**CITY OF LA VISTA
PLANNING DIVISION**
RECOMMENDATION REPORT

CASE NUMBER: 2014-CUP-02

RE: Conditional Use Permit Amendment & Administrative Plat
My Place Hotel
Lot 3, Southport East Replat Three
Initial City Engineer Review

RE: Design Review – My Place Hotel
BCDM Project No. 3700-07

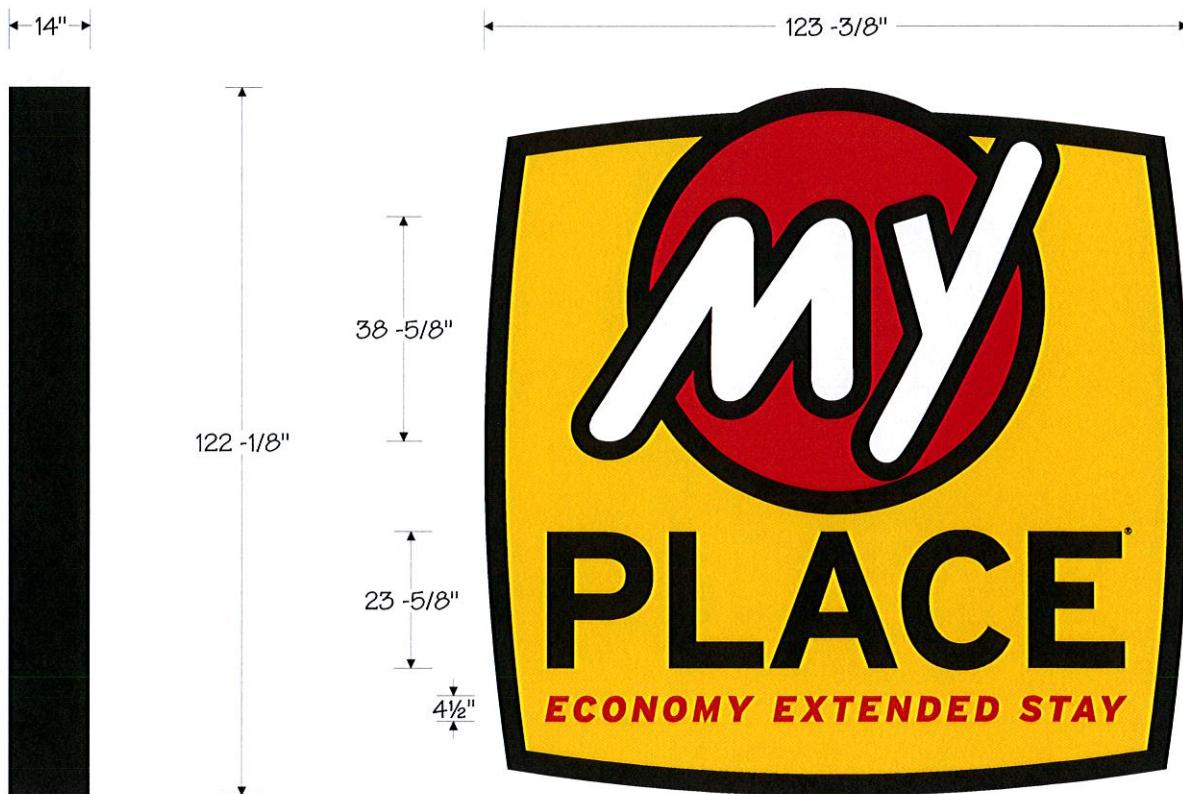
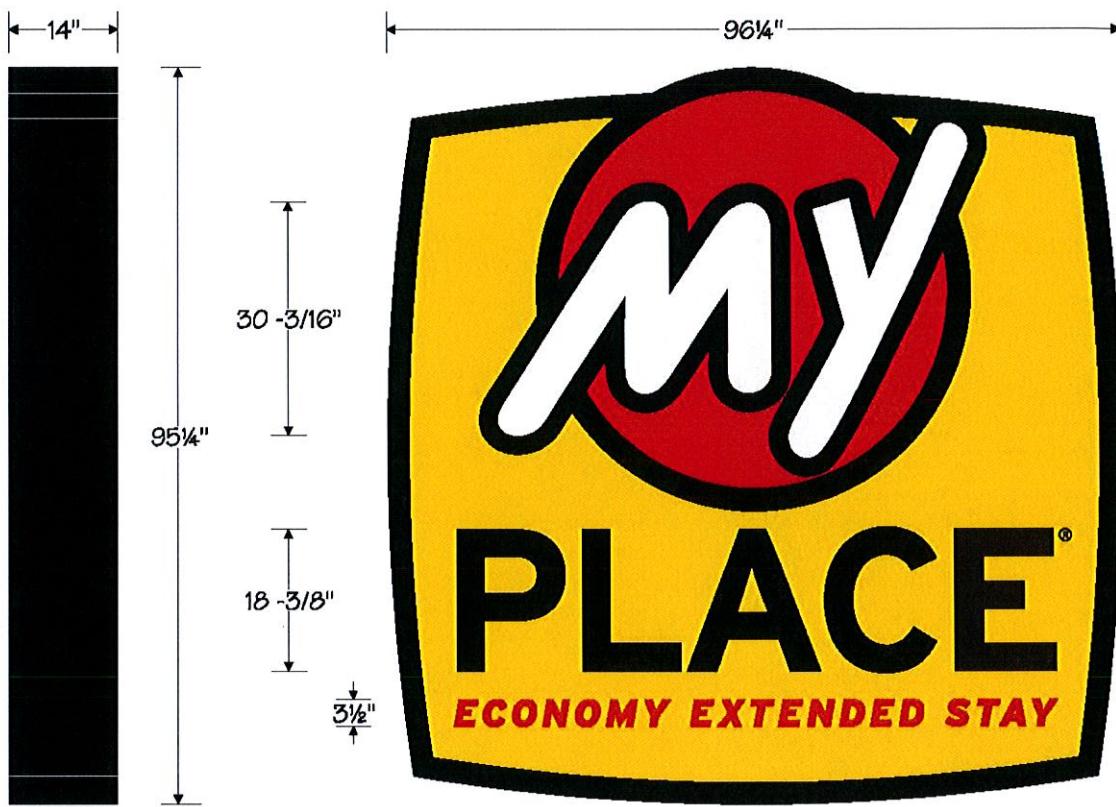
- o Individual can letters on building not shown. Singular sign is not compliant with this requirement. Signage reviewed by City.

Not in Compliance.

Signage has been described in more detail including trademarked signage as shown.

**Signage is required to be modified to comply with guidelines. (See Fantasy Car Wash
ie.) Signage is reviewed by City for compliance.**
